TEMPORARY REVISION NO. 27-29.

Insert facing 27-3-0, Page 2, dated Feb. 15/63 (or subsequent).

CONVAIR MODEL 30

MAINTENANCE MANUAL

Spoiler/Speed Brake Mixer Installation
Figure 201 (Sheet 1 of 2)

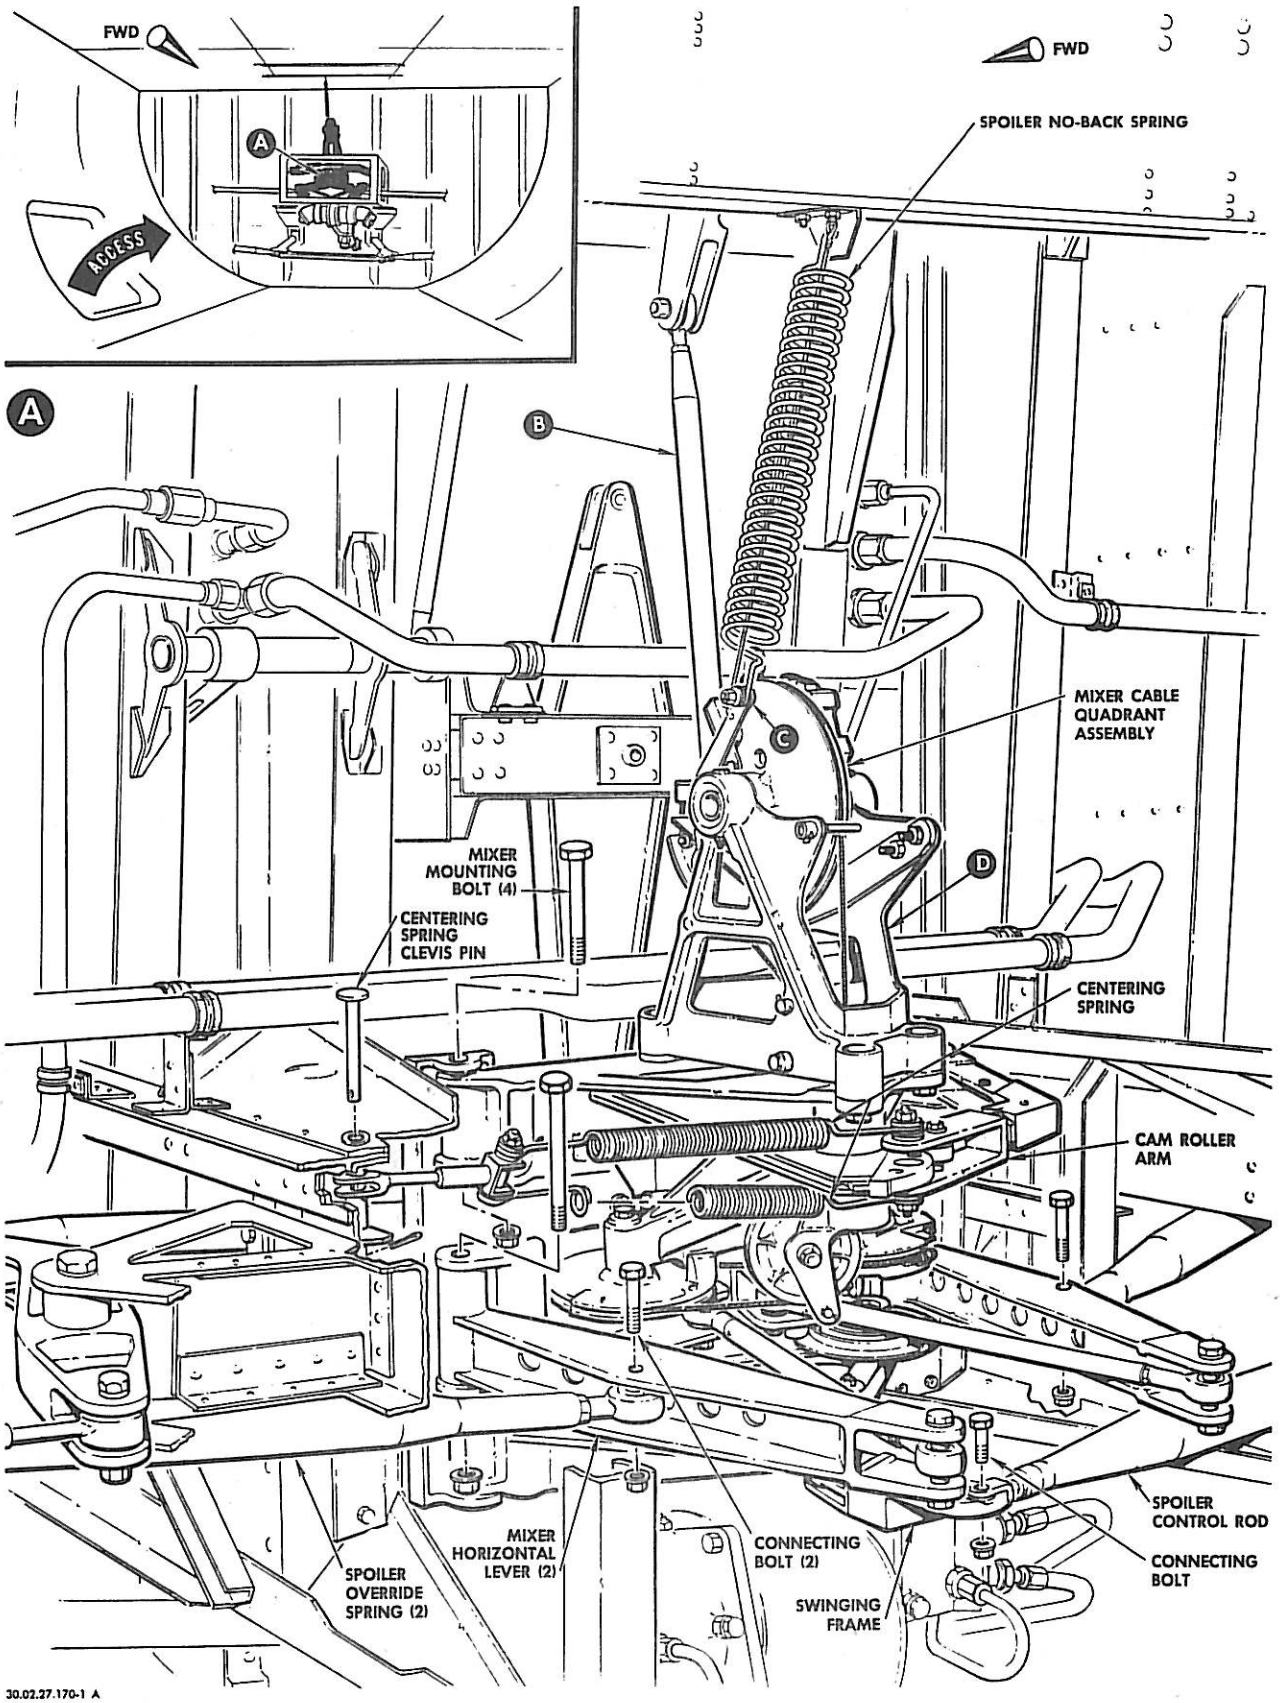
The illustration on sheet 2 of this temporary revision is applicable to airplanes not modified per Service Bulletin No. 27-25. For airplanes that have been modified per Service Bulletin No. 27-25, use the illustrations on 27-3-6, Pages 202 and 203.

ning Horn Circuit
Figure 6

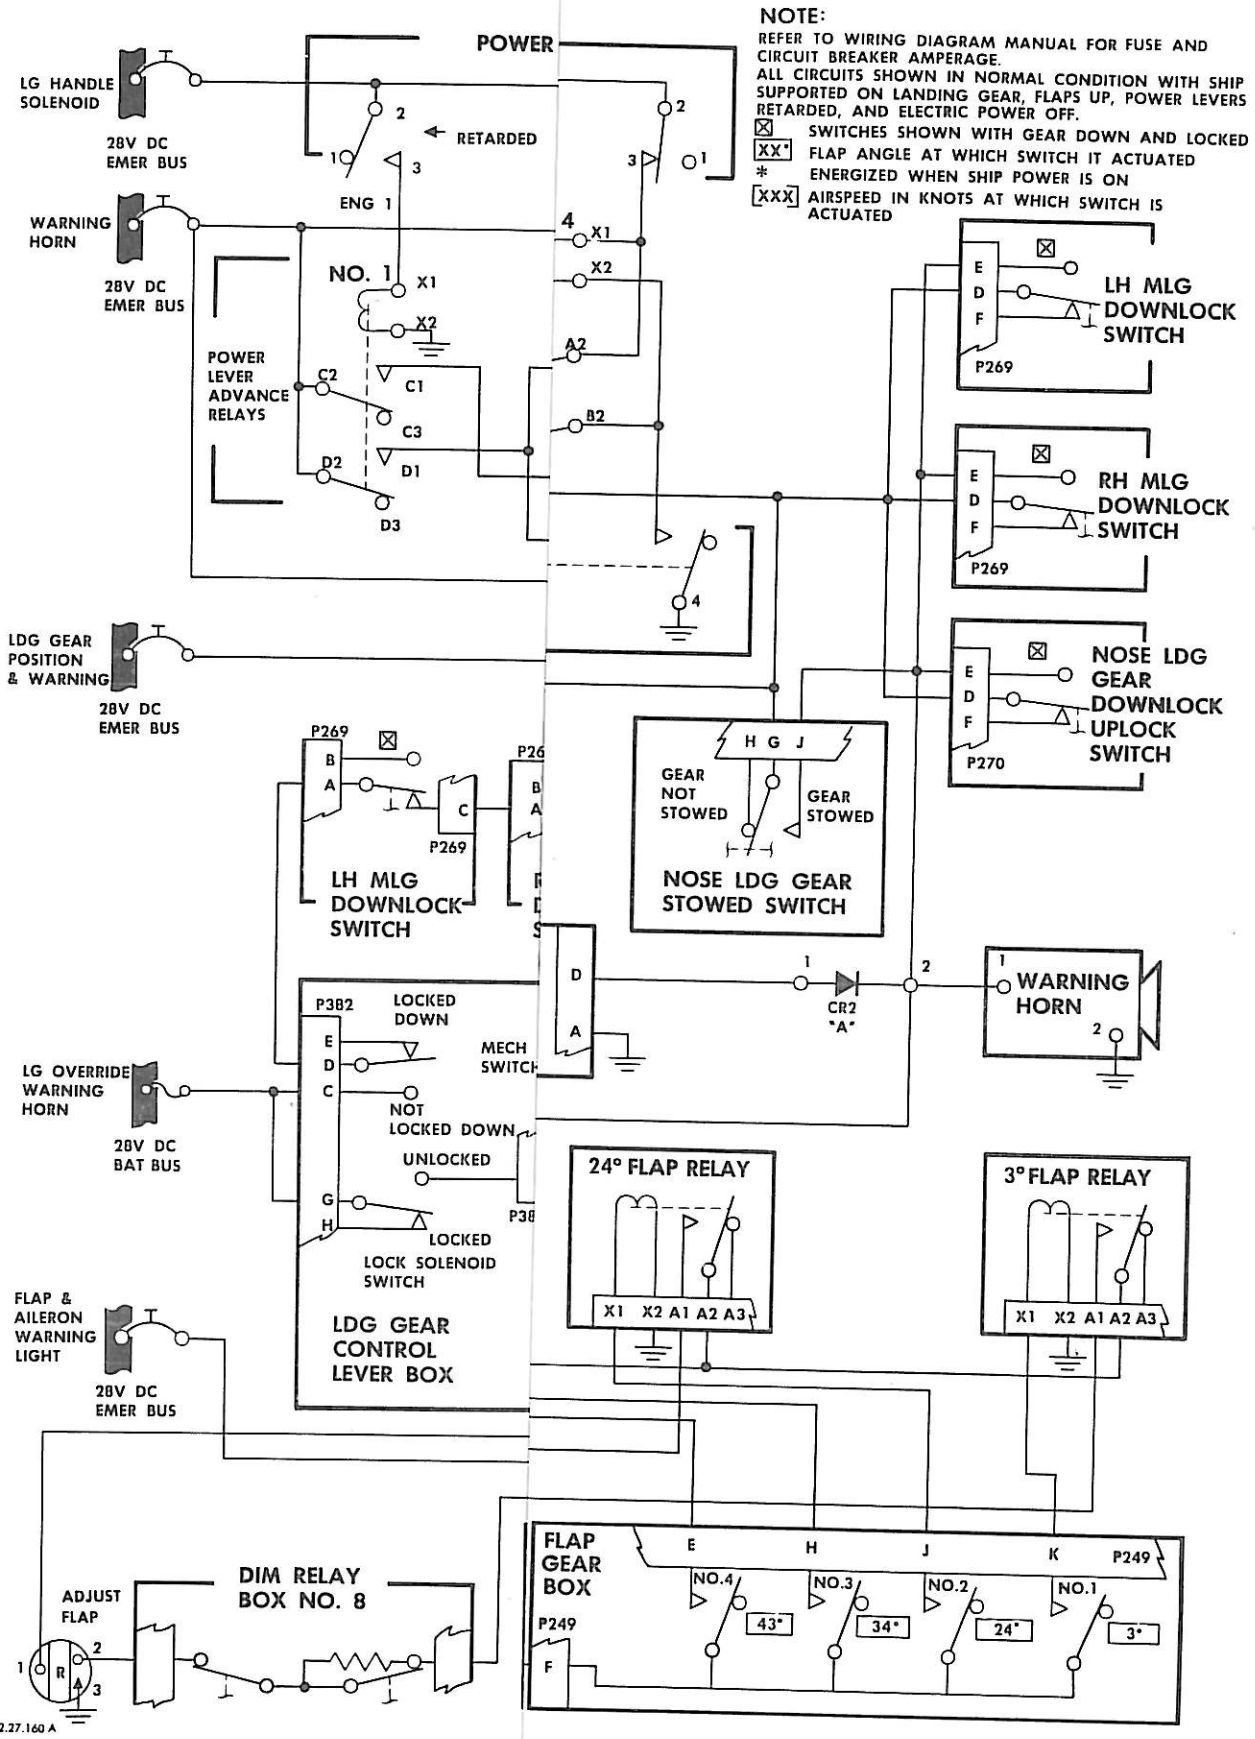
Page 13, delete the 3 degree, 24 degree, 34 degree and 43 degree flap relays from flap and aileron warning circuit. (The airspeed warning control switches in the flap gear box are connected directly to the flap angle position switches in the airspeed warning control.)
